**COUNTY OF MIDDLESEX - INTERROGATORY #1**

Filed: May 23, 2013  
EB-2013-0040 and EB-2013-0041  
Exhibit B  
Tab 1  
Schedule 3  
Responses to County of  
Middlesex Interrogatories  
Appendix A

AREA	SUBJECT
1001 115kV TRANSMISSION LINE	STEEL POLE DESIGN PLAN & PROFILE DRAWINGS SHEET 1 OF 12
CLIENT DWG. NO.	REV.
DRAWING NO. 1235-2-P012-S1	G

**APPENDIX 'B'**

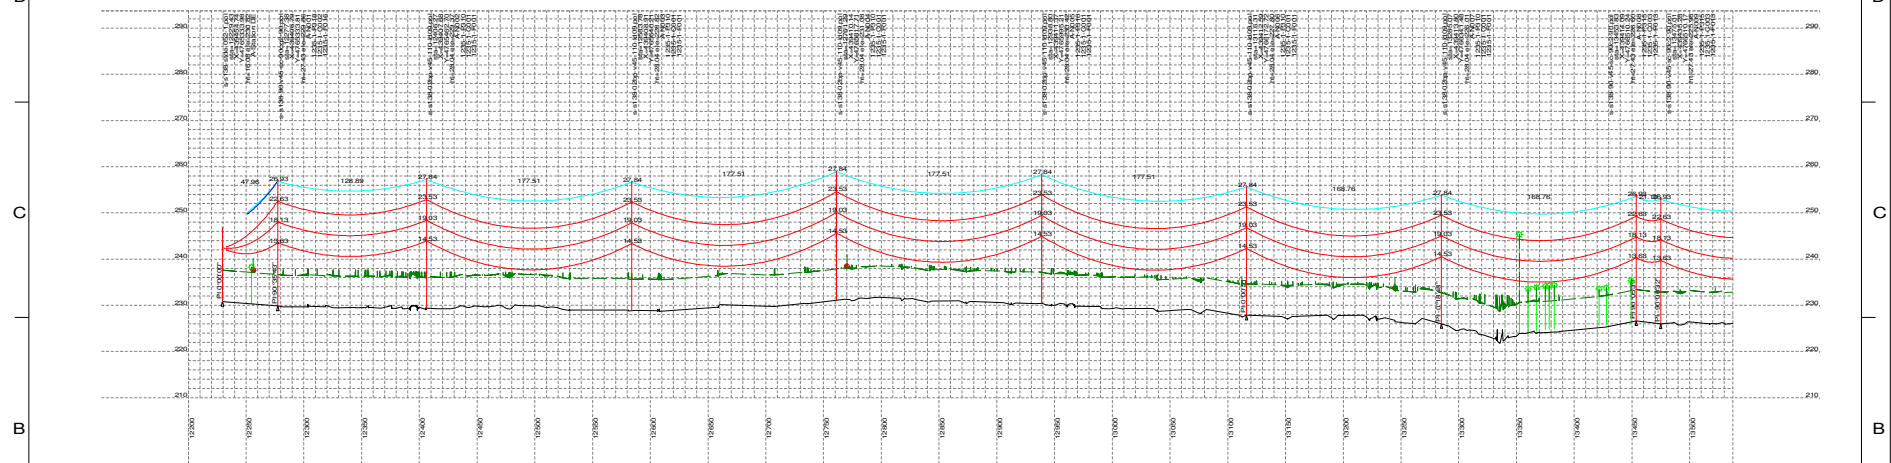
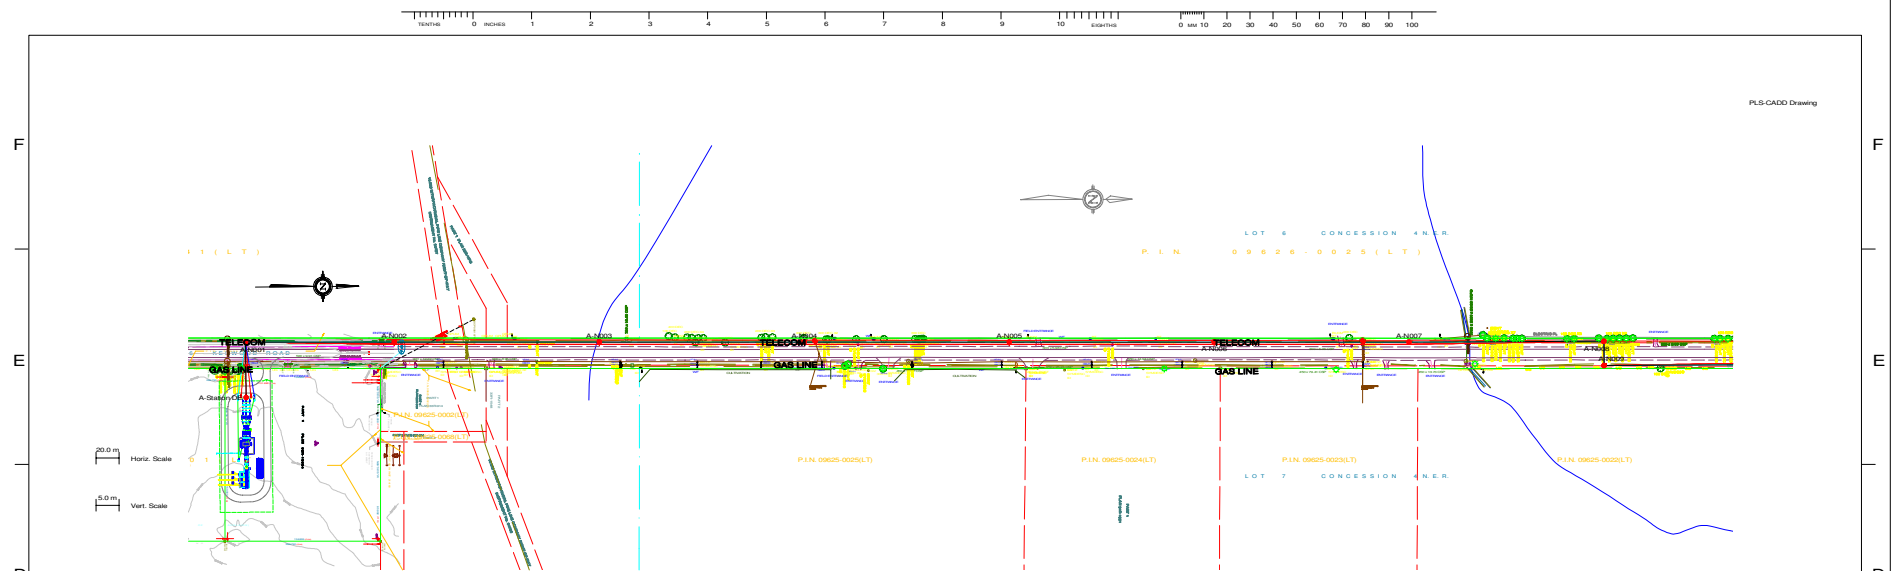
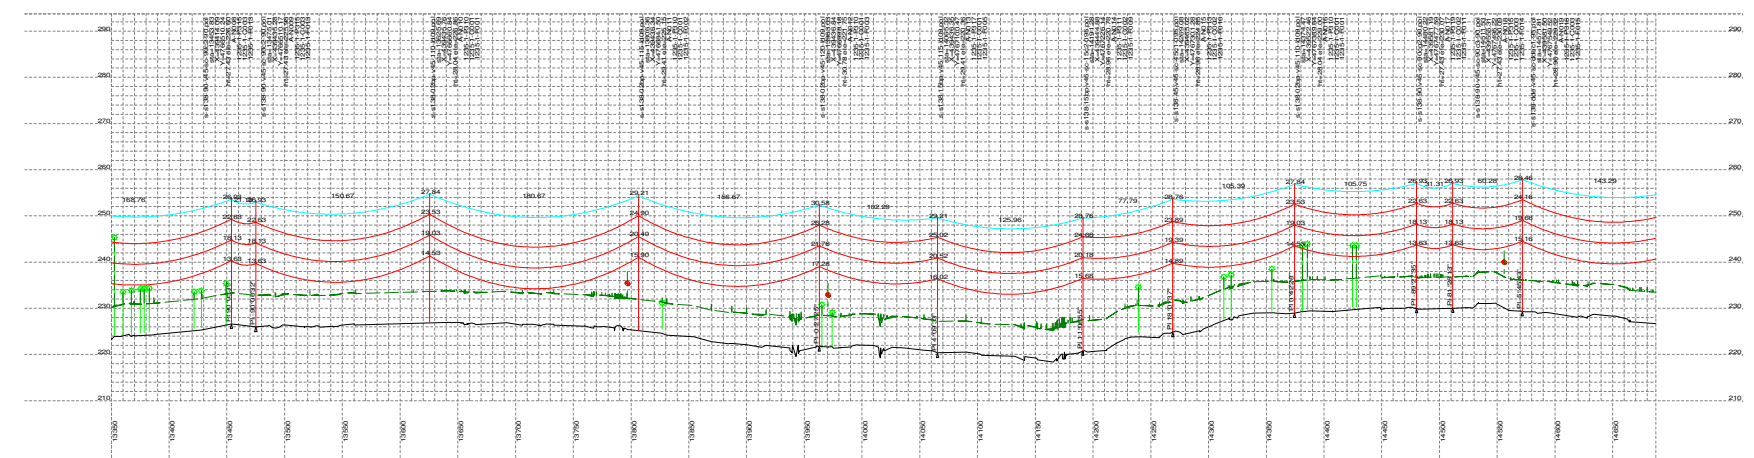
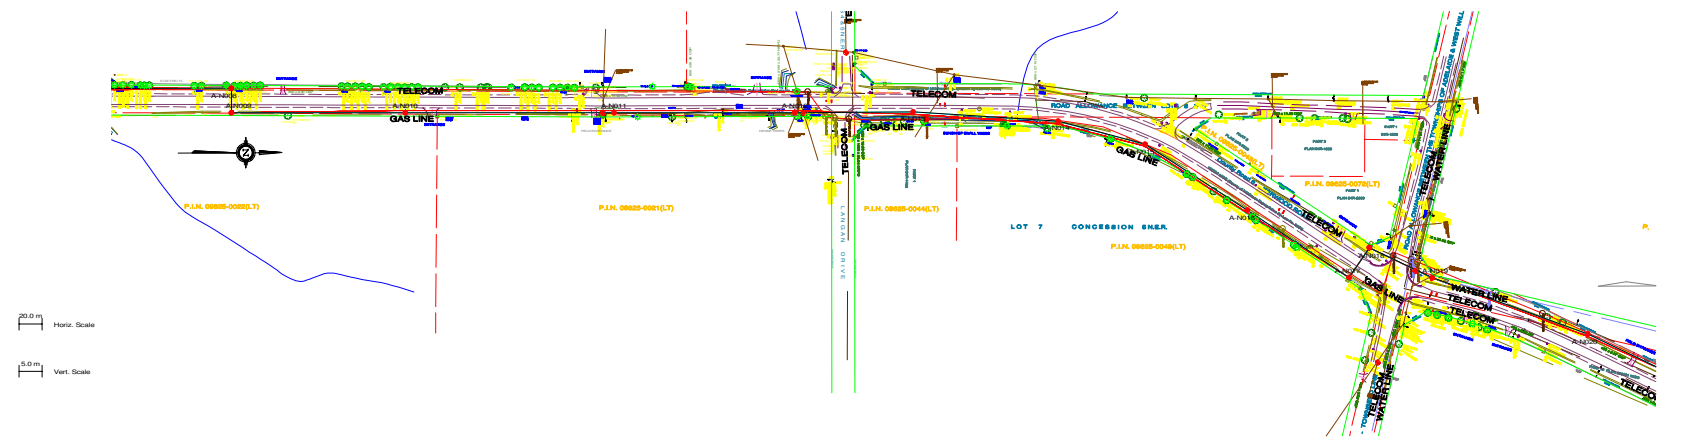
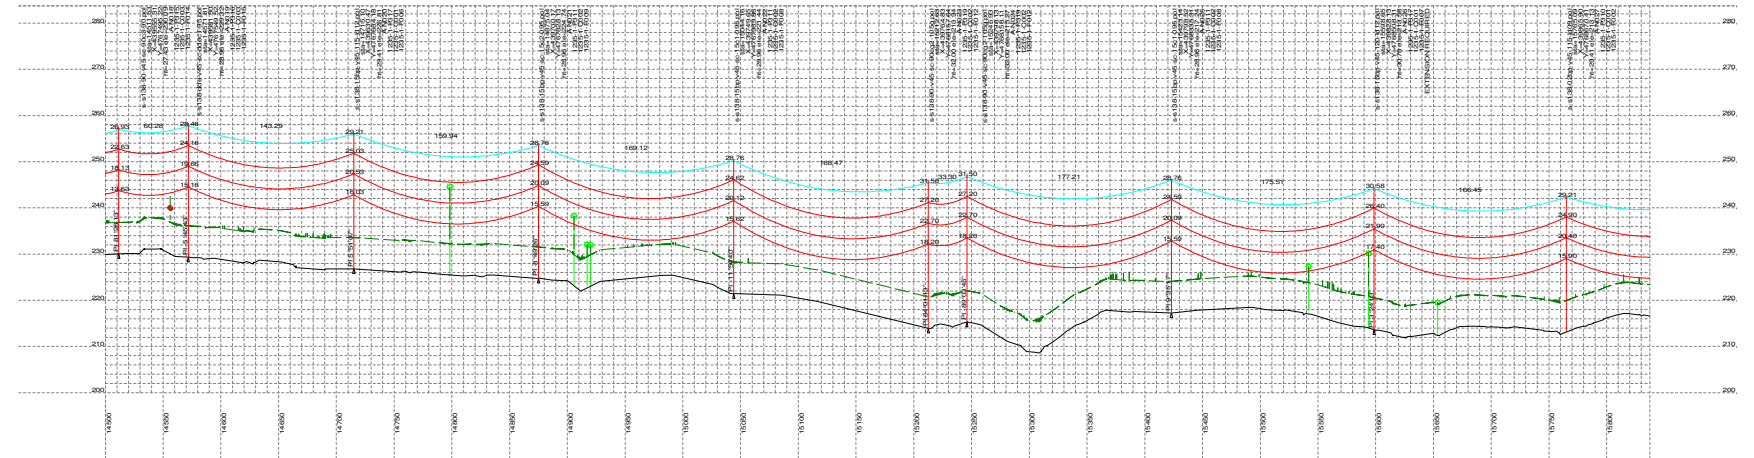
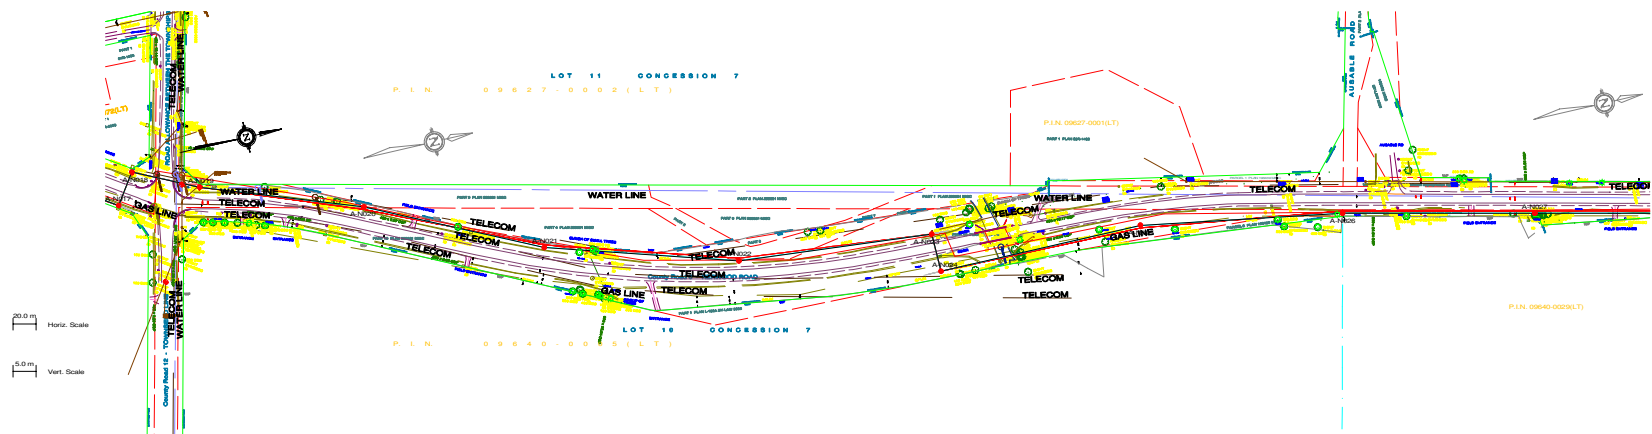
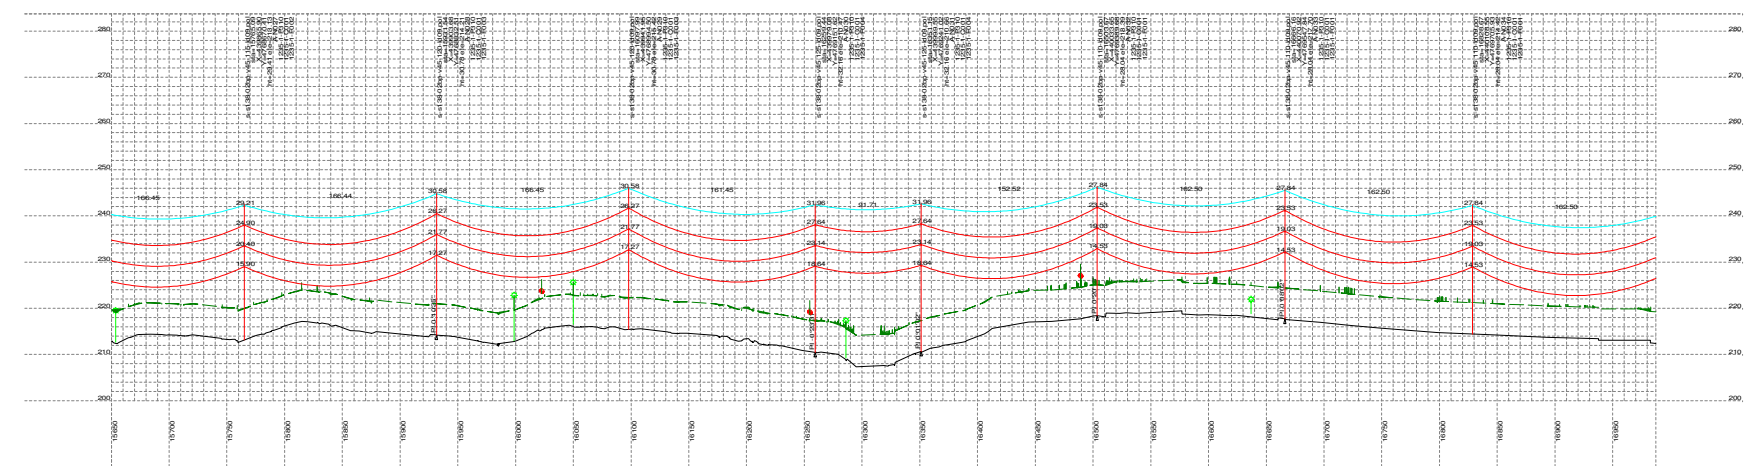
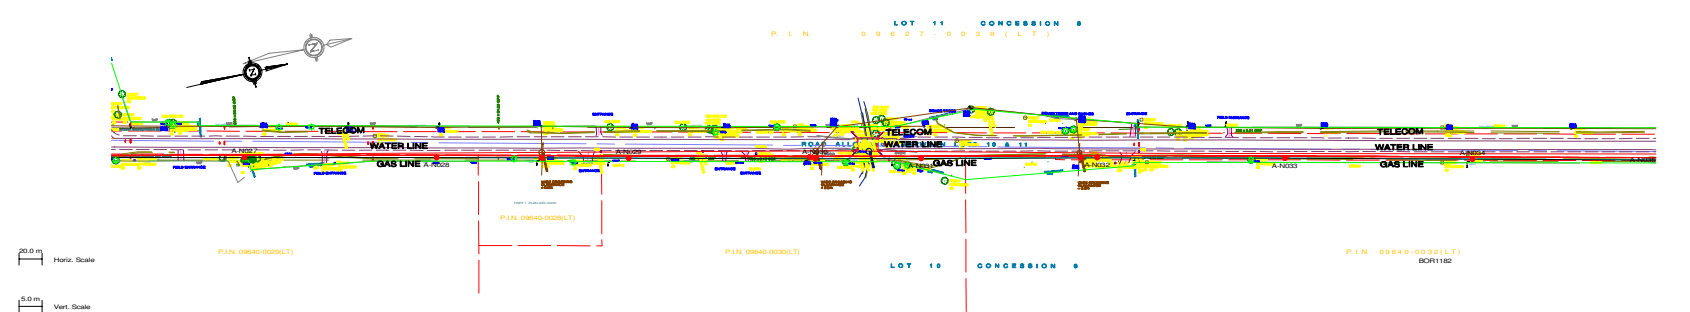
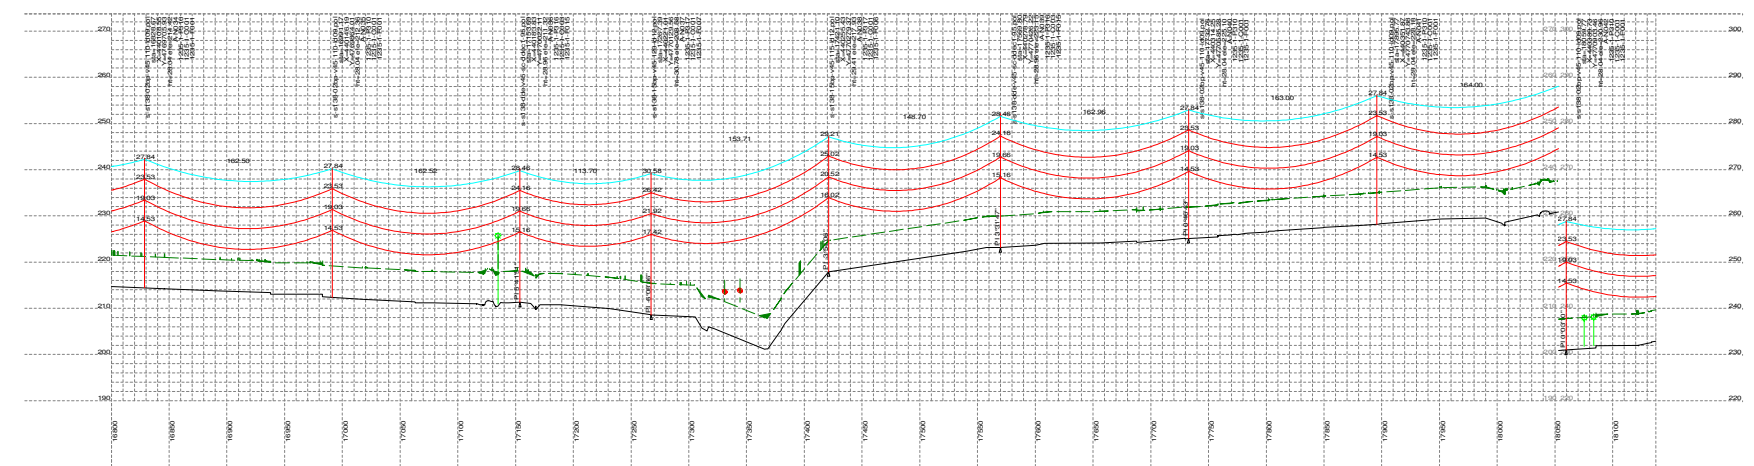
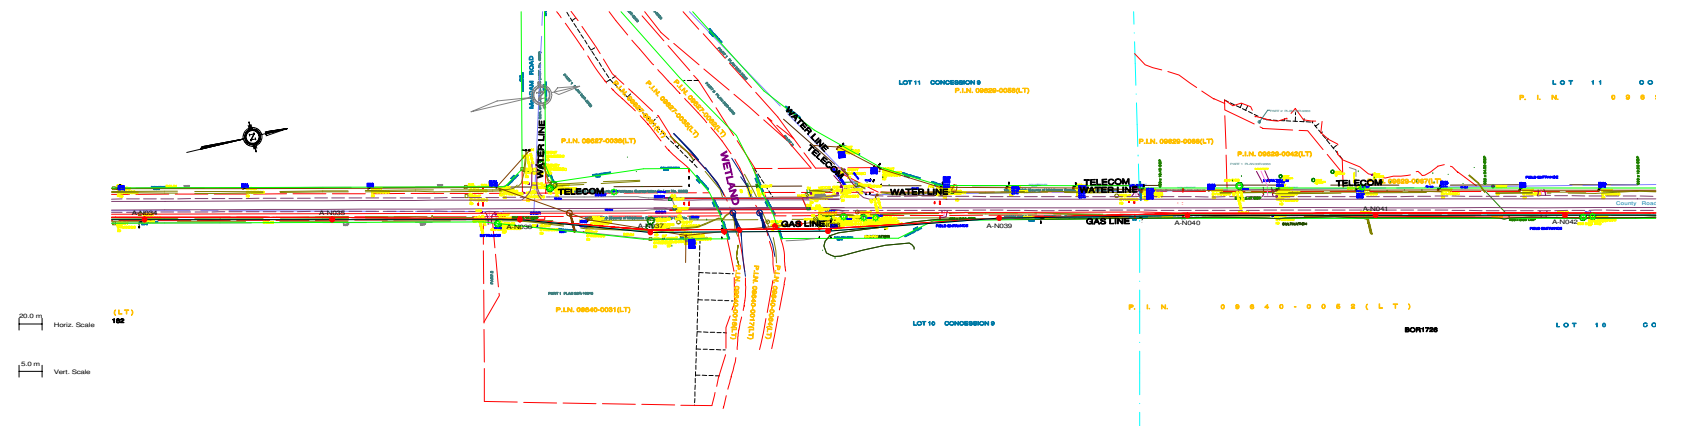
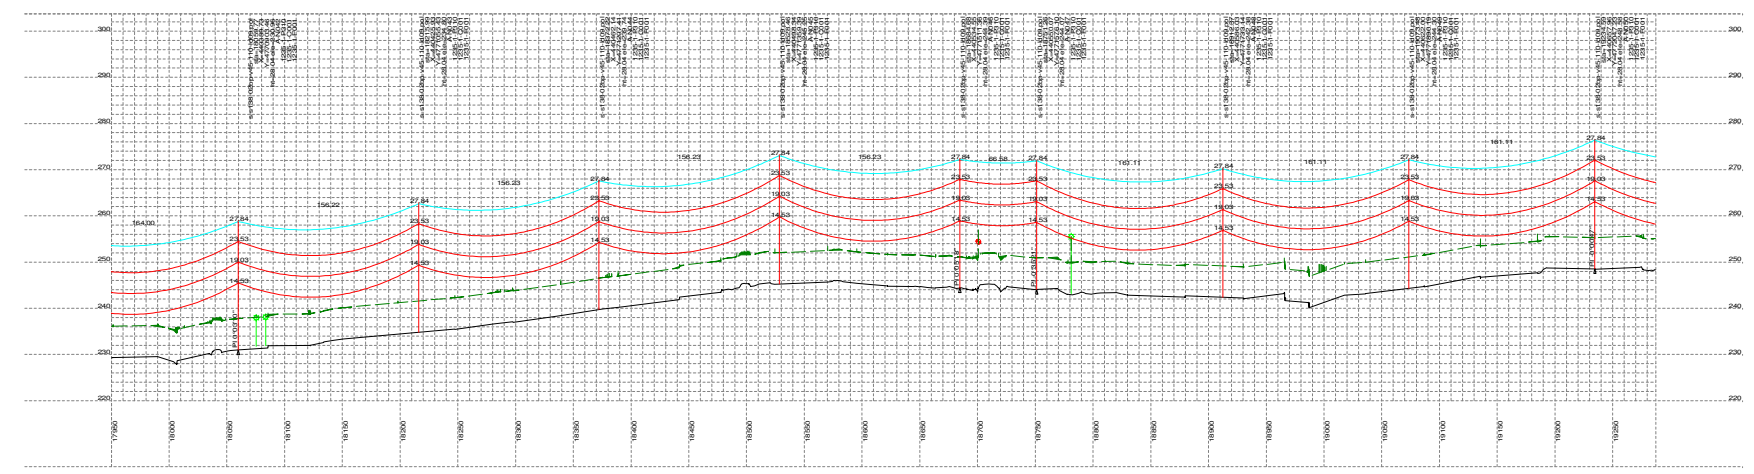
Please provide detailed engineering drawings showing the exact location of all poles and other appurtenances proposed to be located within County road allowances for transmission lines, including all material and construction specifications of poles, wires, guying, foundations, trenching, temporary conditions, and any other items related to this infrastructure.

Please see profile drawings in **Appendix 'A'** in respect of EB-2013-0040 and **Appendix 'B'** in respect of EB-2013-0041 depicting the current design, which is subject to final engineering. Earlier versions of these sets of drawings were provided to the County's Engineer on November 12, 2012. These drawings show the proposed pole, wire and anchor locations. Plans with respect to foundations, materials and construction specifications are not yet finalized. The physical design specifications for the proposed transmission line, including with respect to potential materials, are described in Exhibit D, Tab 1, Schedule 1. In addition, illustrations of potential pole structures and framing designs are provided in Figure 4 of Exhibit B, Tab 2, Schedule 5.
